MONITORING YEAR 4 ANNUAL REPORT

SHAKE RAG MITIGATION SITE

RE: Draft MY4 Report Review
Shake Rag Mitigation Site, Madison County
French Broad River Basin: 06010105
DMS Project ID No. 100018
DEQ Contract #7190

Wildlands Engineering, Inc. (WEI) has reviewed the Division of Mitigation Services (DMS) comments from the Draft Monitoring Year (MY) 4 report for the Shake Rag Mitigation Site. DMS' comments are noted below in **bold**. Wildlands' responses to those comments are noted in *italics*.

Figure 3.1 Monitoring Plan View Map
Shake Rag Mitigation Site
DMS Project No. 100018
Monitoring Year 4 - 2023

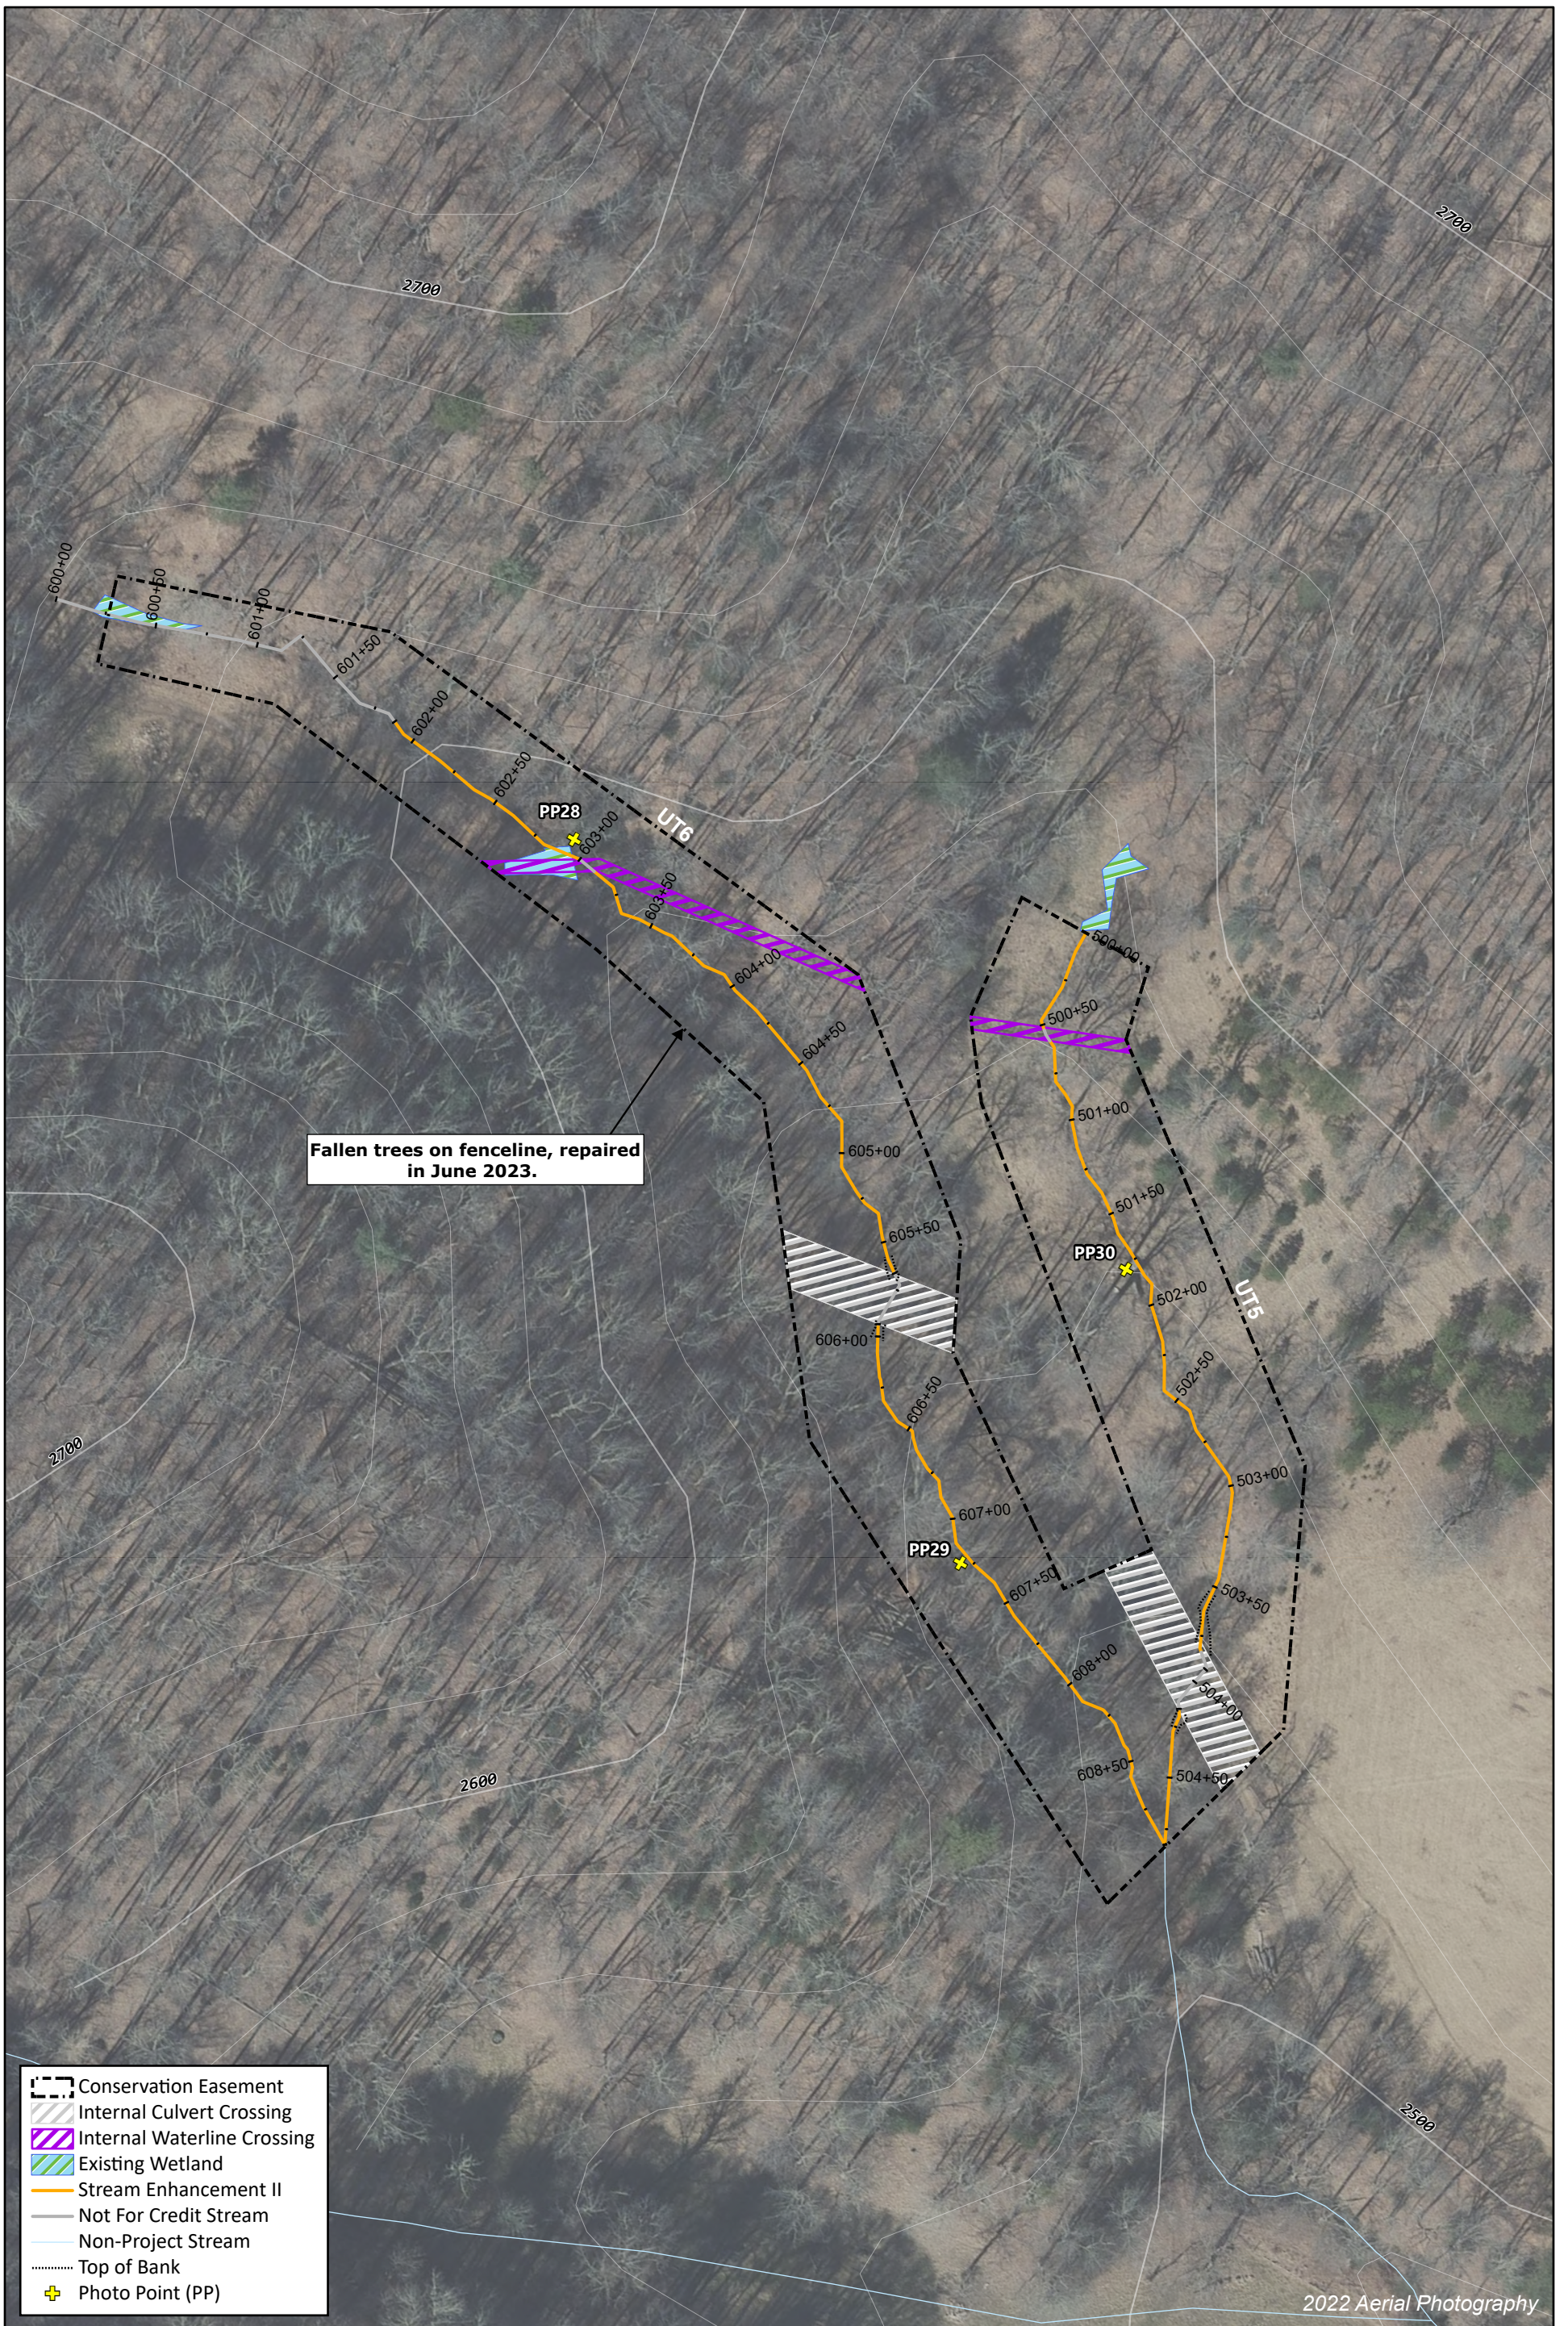
Does WEI have any before/after pics of the UT3 side slope areas of poor growth that received reseeded and compost tea in MY4? Please add this area to the MY4 CCPV.

DMS appreciates the Conservation Easement Boundary Issue Table that was included in the MY4 report. Please include the resolved conservation easement boundary issues on the MY4 CCPV.

Wildlands' response: Before/after photos of the UT3 side slope areas have been added to a photolog in Appendix 2. This area of improved herbaceous cover has been added to the MY4 CCPV (Figure 3.2).

Wildlands' response: The resolved conservation easement boundary issues have been added to the MY4 CCPV figures.
